## **T10/07-391 revision 1**

From: George Penokie (IBM)

Subject: SAS-2: Limiting SAS Target response to OPEN\_REJECT (RETRY)

**Figure 1 — Port layer examples**

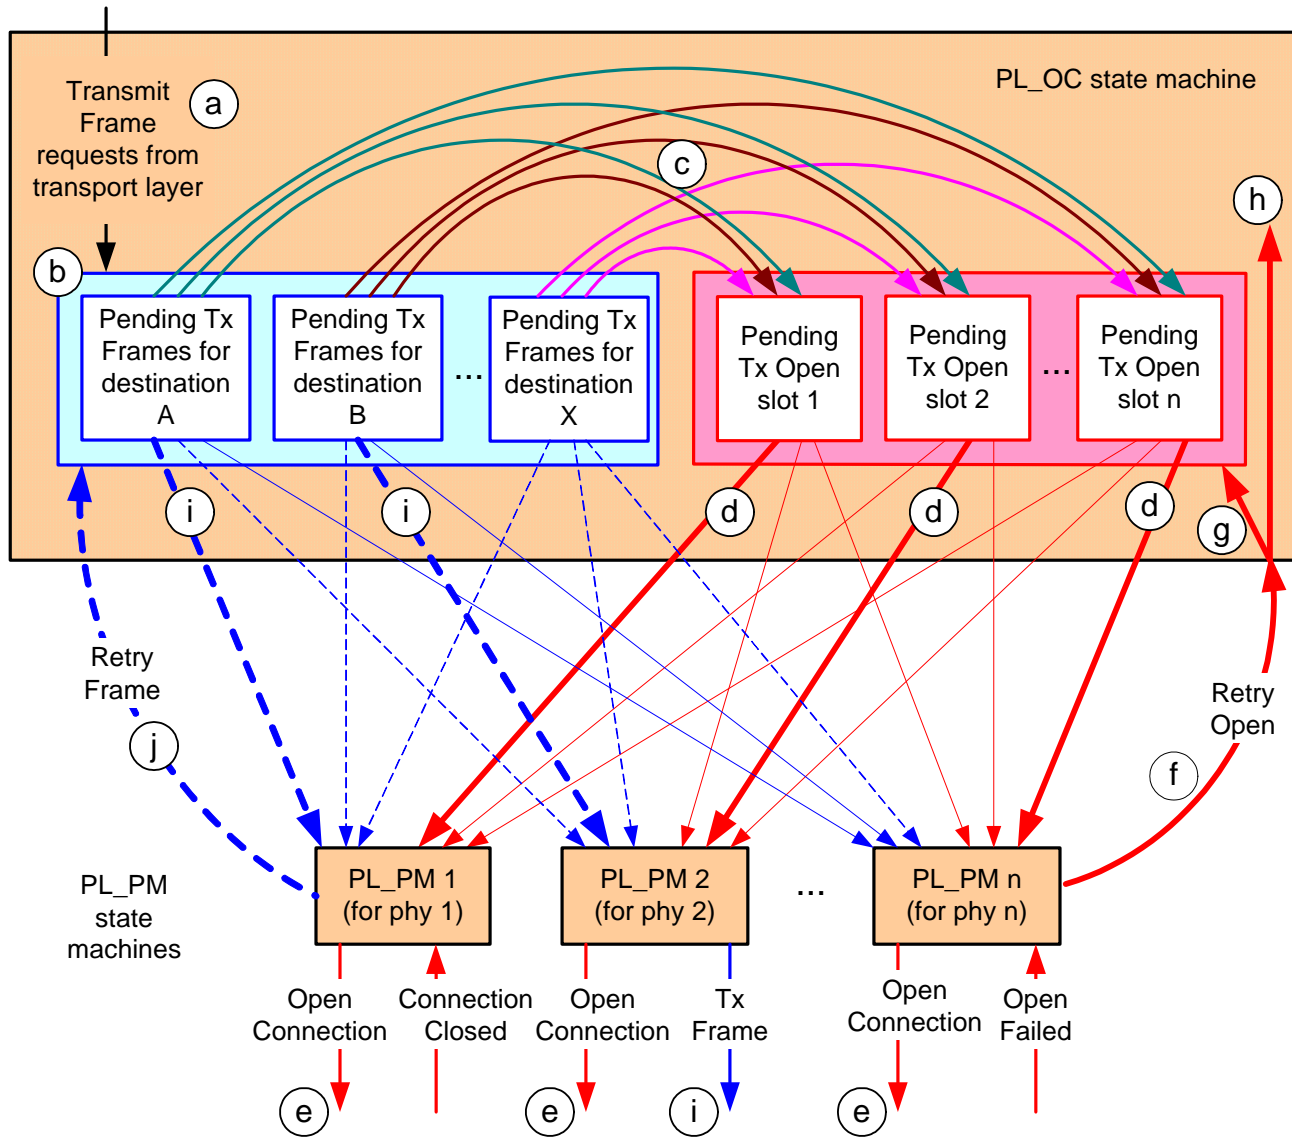
- g) [after a reject to open limit timer has expired, if any](#), the PL\_OC state machine converts a Retry Open message to a pending Tx Open message if there is a pending Tx Open slot available;

Editor's Note 1: The current item g should be split into two entries at the ;
